Subject: AP1000 COL Response to Request for Additional Information (TR 36)

Response to Request for Additional Information on Technical Report No. 36

RAI Response Number: RAI-TR36-012

## Response to Request For Additional Information (RAI)

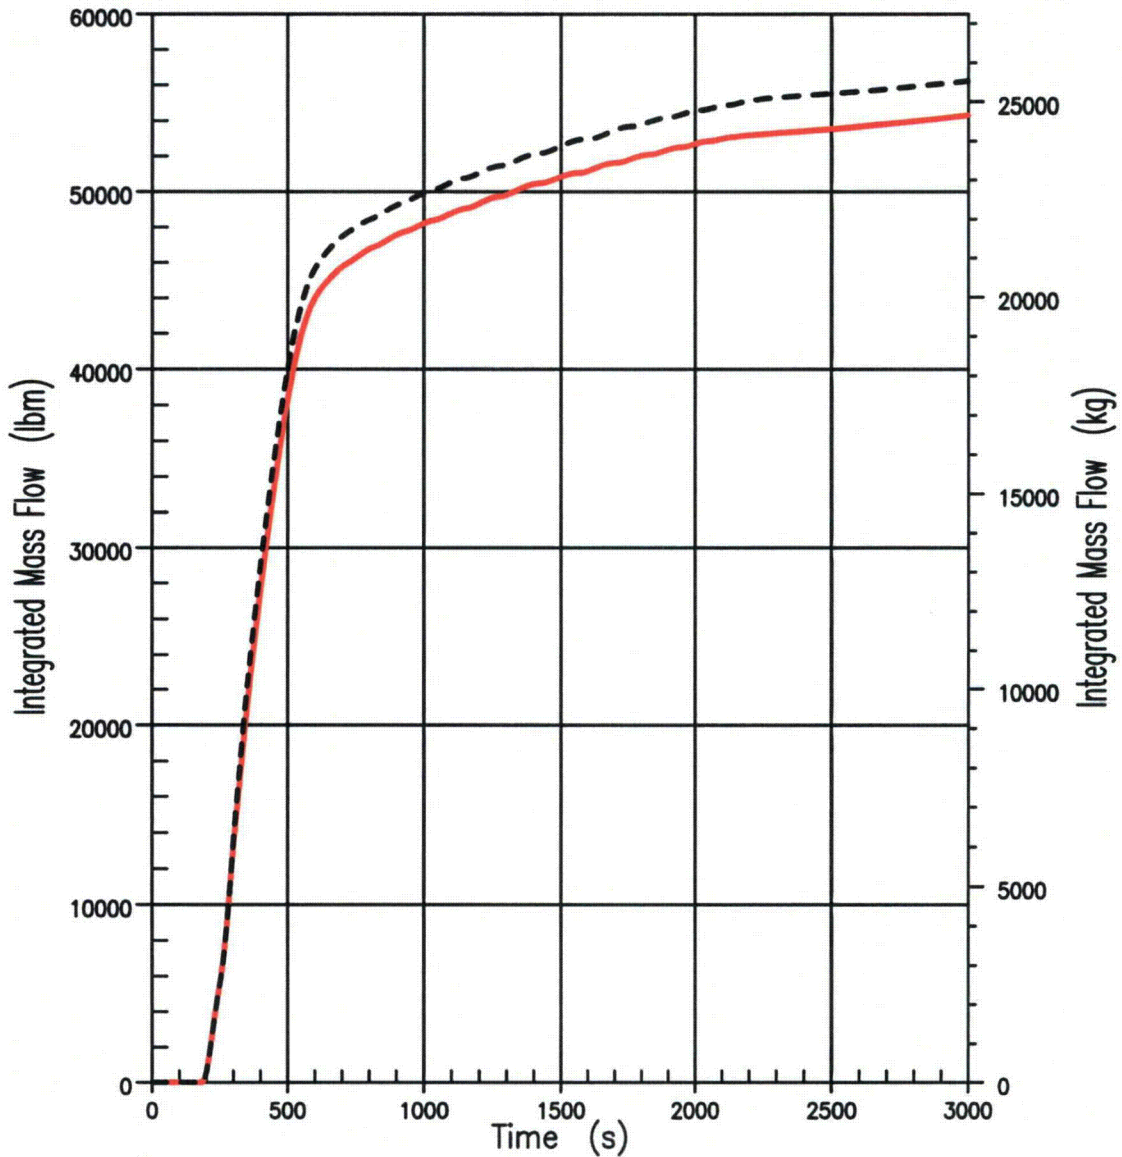
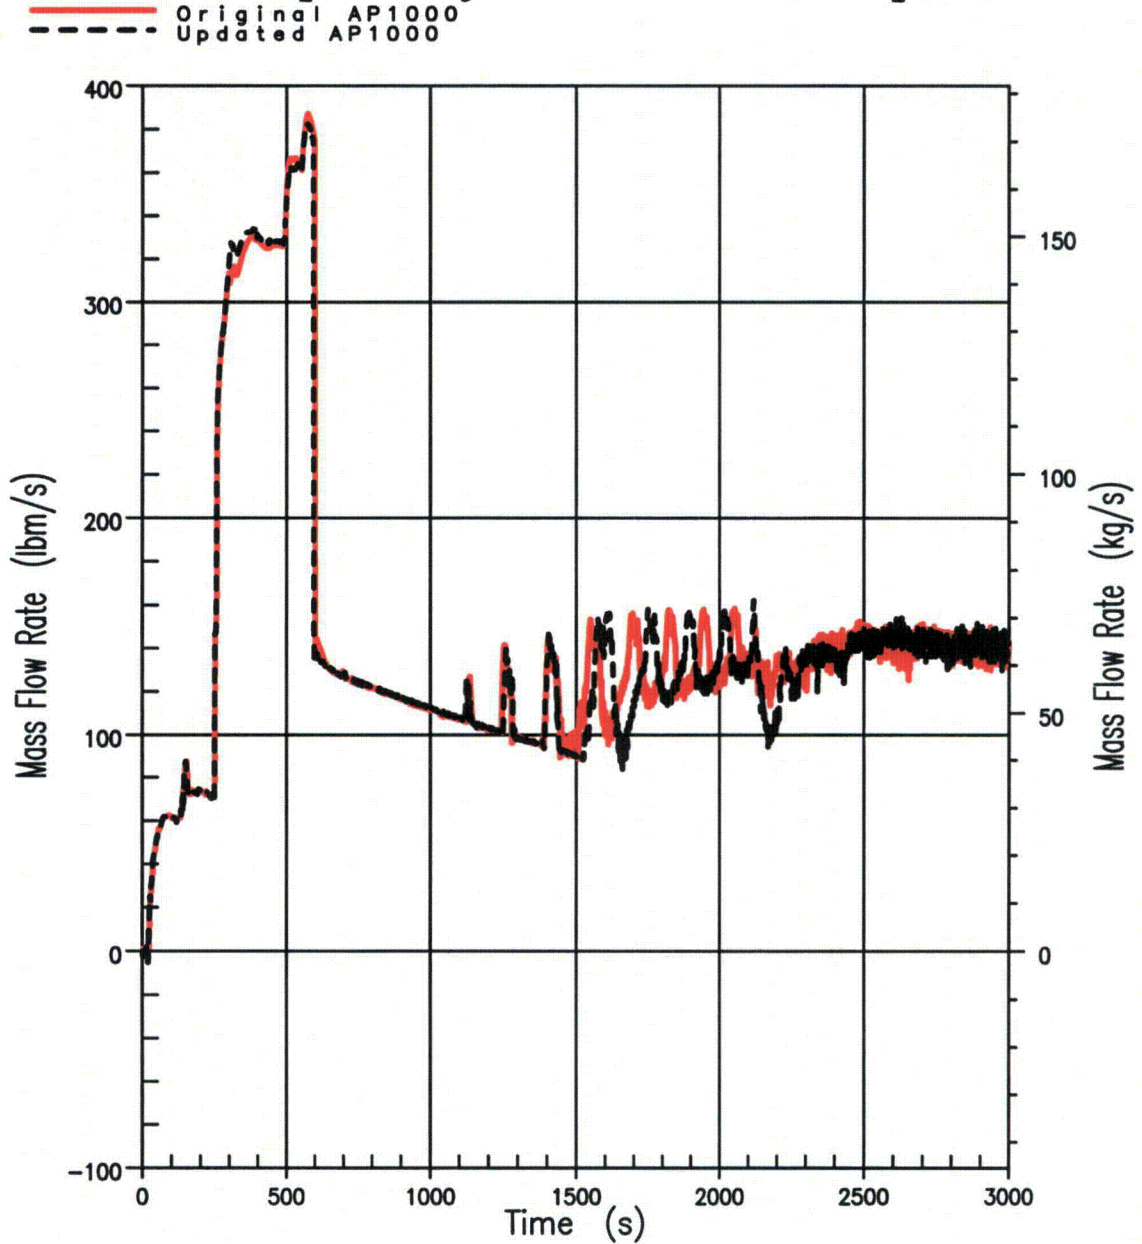
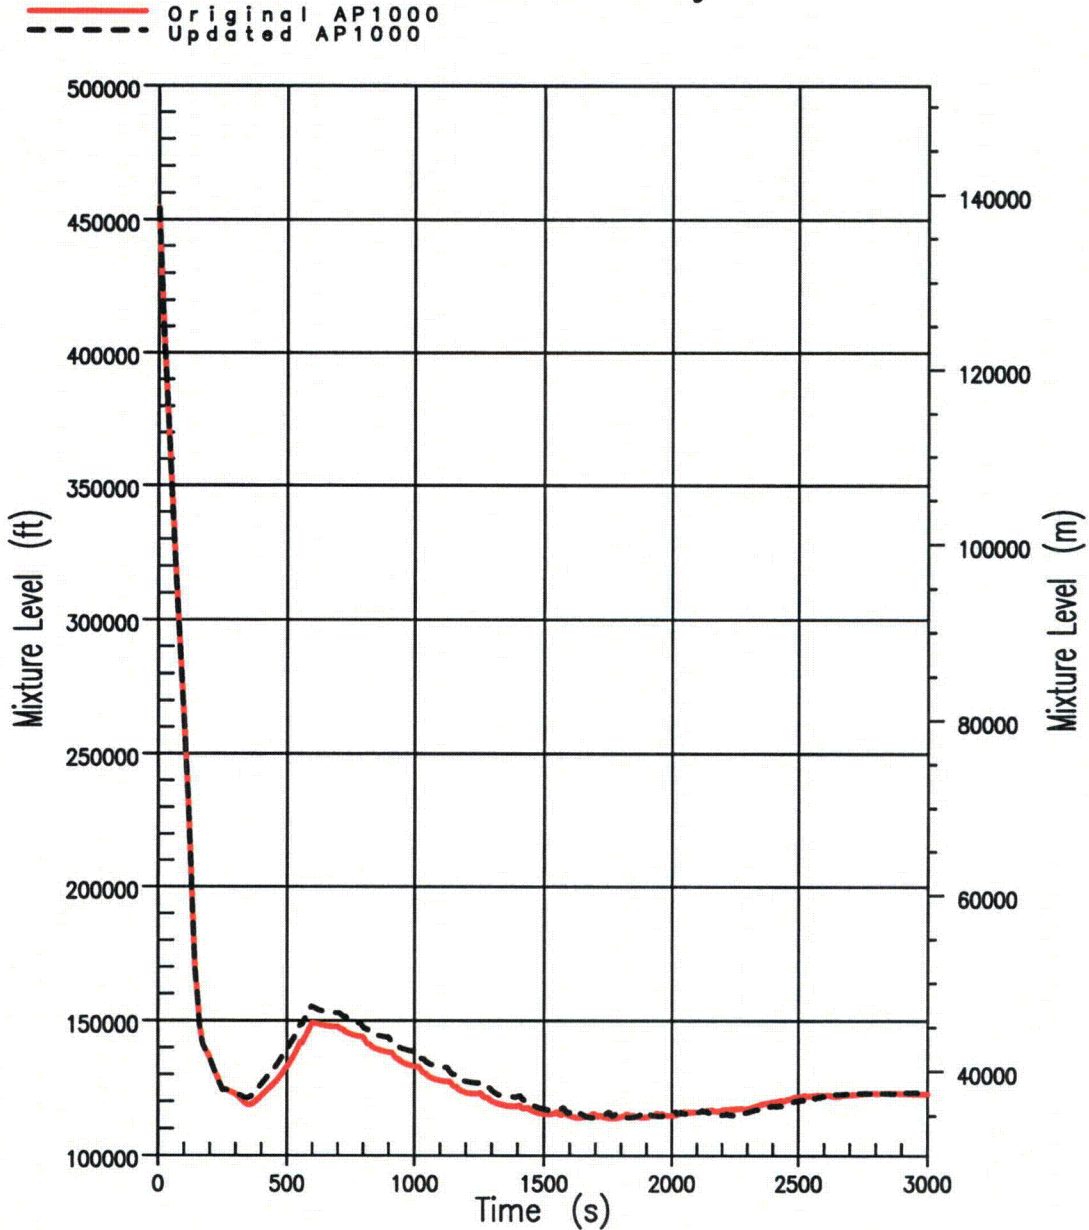
The pressurizer changes affect many parameters such as the cross-sectional area of the pressurizer, pressurizer vessel height, initial pressurizer water level, pressurizer setpoints, ADS stages 1, 2, and 3 elevation and pressurizer heater length. We are concerned about the combined effects of the values changed for the above parameters on the thermal hydraulic response during transient and accident conditions. We determined that the qualitative statement in the RAI response is not sufficient to resolve the RAI issue. We request Westinghouse perform the quantitative analyses for the limiting event for each of the following Standard Review Plan chapter 15 event categories:

Table 6.3-1 and Figures 6.3-1 through 6.3-9 present a comparison of the DEDVI line break simulations. The results demonstrate the effect of the change in the pressurizer tank diameter, that being the decrease in both the Pressurizer Mixture Level (Figure 6.3-4) and Pressurizer Void Fraction (Figure 6.3-5). This subsequently reduces the Automatic Depressurization System (ADS) Stage 1-3 liquid discharge (Figure 6.3-6) and increases the ADS 1-3 vapor discharge (Figure 6.3-7). The overall effect is that slightly more Reactor Coolant System (RCS) inventory remains in the RCS for a majority of the transient simulation period (Figure 6.3-9). No significant changes in the RCS Pressure (Figures 6.3-1 and 6.3-2), Core Mixture Level (Figure 6.3-3) and DVI injection characteristics (Figure 6.3-8) are observed as a result of the design change implementation.
